BOARD MEETING DATE: April 5, 2024

PROPOSAL: Determine That Proposed Amended Rule 1118 – Control of Emissions from Refinery Flares, Is Exempt from CEQA; and Amend Rule 1118

SYNOPSIS: Proposed Amended Rule 1118 (PAR 1118) seeks further control and reduction of flaring and flare related emissions at refineries, hydrogen production plants, and sulfur recovery plants and establishes new requirements to monitor and record flaring data. PAR 1118 will reduce emissions from refinery flares by lowering the sulfur dioxide performance target for general service flares, establish a new NOx performance target for hydrogen production plants, and establish a throughput threshold for clean service flares. PAR 1118 will also increase mitigation fees and fulfill the Assembly Bill 617 Wilmington, Carson, West Long Beach Community Emission Reduction Plan air quality commitment objectives related to refinery flaring.

Figure 2-7. Sulfur Dioxides Content from Clean Service Flares by Facility

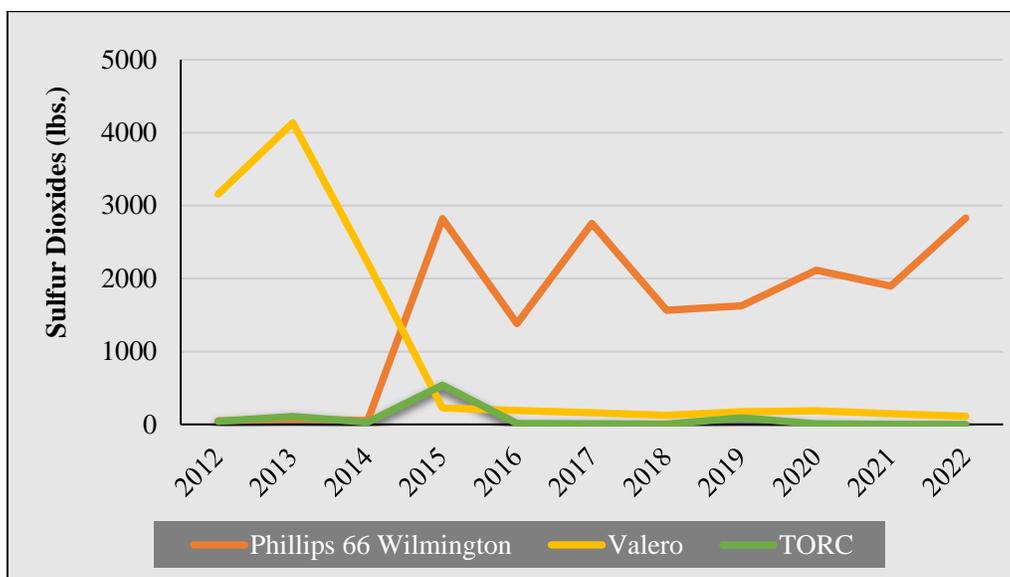
¹¹ While general service flares have higher total emissions and emit additional pollutants (like SO_x), Clean Service flares have significant emissions without much regulation. Also, clean service flares *do* contain some sulfur, particularly at Phillips 66 Wilmington, which included thousands of pounds per year of SO_x emissions from "clean service" flares.¹¹ Working Group Staff Report, Figure 2-7. Sulfur Dioxides Content from Clean Service Flares by Facility, p. 2-7

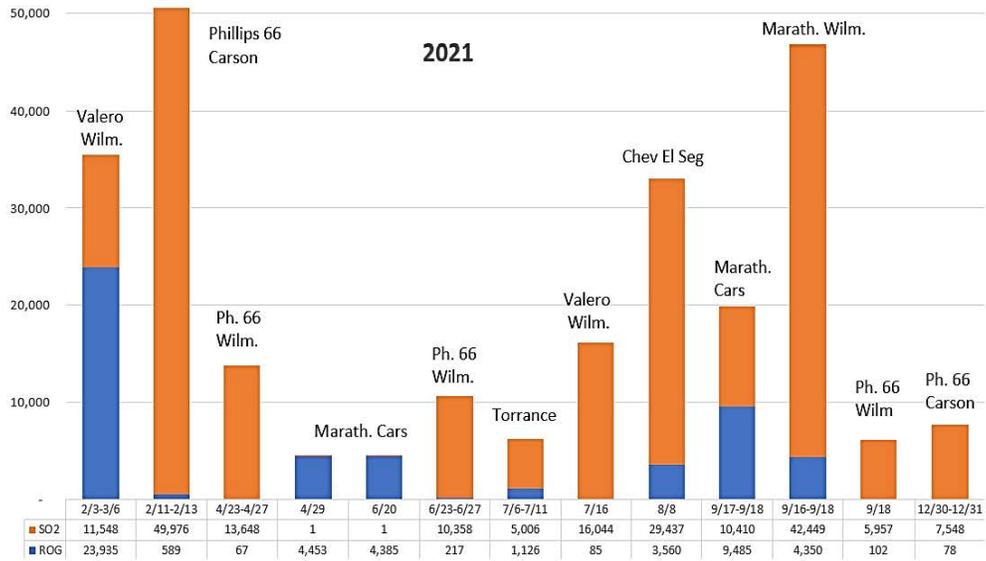
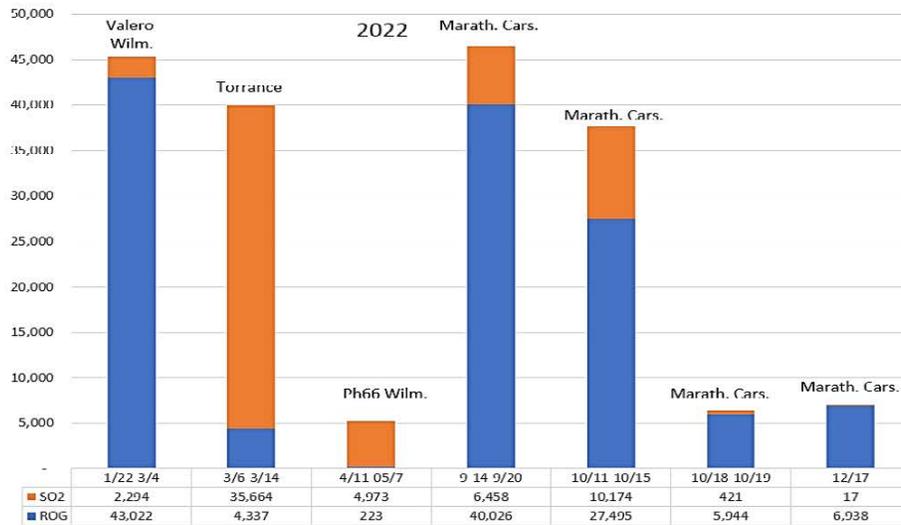
The charts below show the largest of both SOx and VOC flaring in 2020-2022. (These do not show many other smaller flaring events that also dump cumulatively large volumes of SOx and VOCs to the air each year). SOx reductions from refineries was a major goal set by the Wilmington, Carson, Long Beach Community Emission Reduction Plan (CERP), although SOx reductions have also been an important goal of the District since its inception, due to the harmful impacts on health.

B. An Annual VOC target is completely missing

The charts above don't even show the full extent of the VOC flaring problem – only the largest events. **Frequent smaller events occur every year, adding up to hundreds of thousands of pounds.**

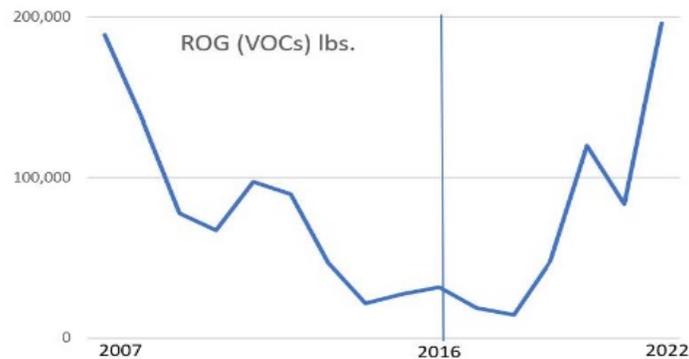
In addition to individual events, total annual emissions can be graphed. Based on aggregated quarterly data reports AQMD provides online, we charted the trend in total VOCs from flares over the years. (2016 is delineated because Torrance had particularly high flaring that year, with major Notices of Violation.) Note that after the 2017 flare rule update, some VOCs changed to higher emission factors. (EPA found flare destruction efficient not as high as assumed, resulting in higher emissions). Thus VOCs post-2017 are not directly comparable to previous years (which would have been shown even higher emissions.)

Regardless of changes in emission factors post 2017, the chart clearly shows that **past VOC flaring emissions were headed down, but in recent years VOC flaring emissions are headed up.** Total emissions are in the hundreds of thousands of pounds, concentrated in refinery communities.

We urge AQMD to apply to VOCs the same method used to chart tons of SOx per million barrels of crude oil at each refinery, each year (as in Table 3.3 shown earlier).⁶ This would identify the best annual VOC levels of the past, to help identify best practices toward lowering VOC emissions. (We could do the analysis ourselves with available data, but it would be helpful to have such a chart in AQMD's staff report, which includes many other valuable charts).

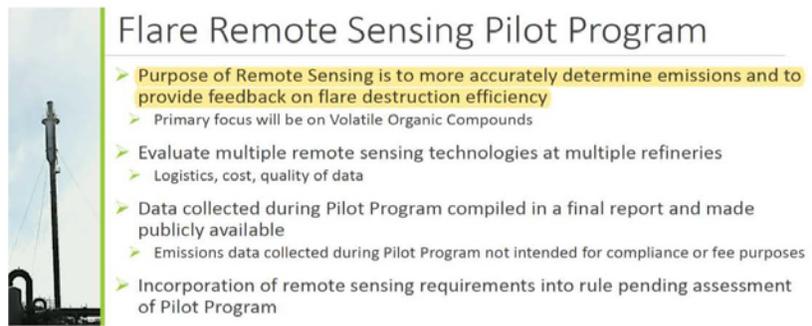
This underestimation also undermines the District’s cost-effectiveness calculations for controlling routine flaring from LPG tanks (discussed above). With propane and butane emissions upward of 73 times higher, cost per ton of reduction is also 73 times less. **The District, after correcting the emissions factors to these much higher levels should re-calculate the cost-effectiveness of controls for non-hydrogen clean service flares.**

This is another reason why specialized Remote Sensing of flares (discussed below) is needed. Especially for flares that operate almost continuously, the District would not have to wait for a flaring event to carry out the monitoring. The District should identify contractors who can perform this monitoring and at least begin pilot testing of flare destruction efficiency and actual VOC emissions.

Flare Remote Sensing Pilot Program

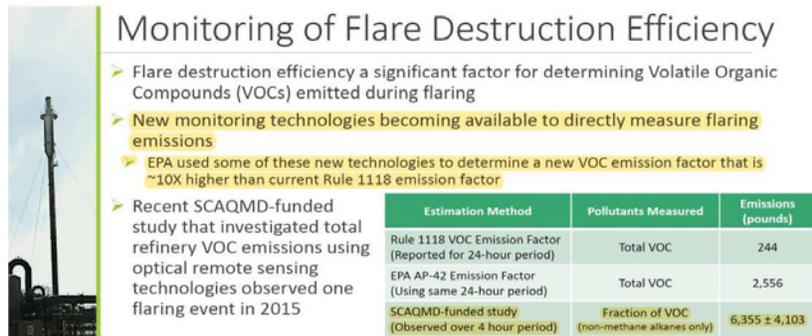
During the 2017 Rule 1118 update 2nd workshop, March 22, 2017, District staff presented the following slides 21, 22, and 23, which summarize Flare Remote Sensing well (highlights added) stating the "Purpose of Remote Sensing is to more accurately determine emissions and to provide feedback on flare destruction efficiency"

- Purpose of Remote Sensing is to more accurately determine emissions and to provide feedback on flare destruction efficiency
 - Primary focus will be on Volatile Organic Compounds
- Evaluate multiple remote sensing technologies at multiple refineries
 - Logistics, cost, quality of data
- Data collected during Pilot Program compiled in a final report and made publicly available
 - Emissions data collected during Pilot Program not intended for compliance or fee purposes
- Incorporation of remote sensing requirements into rule pending assessment of Pilot Program
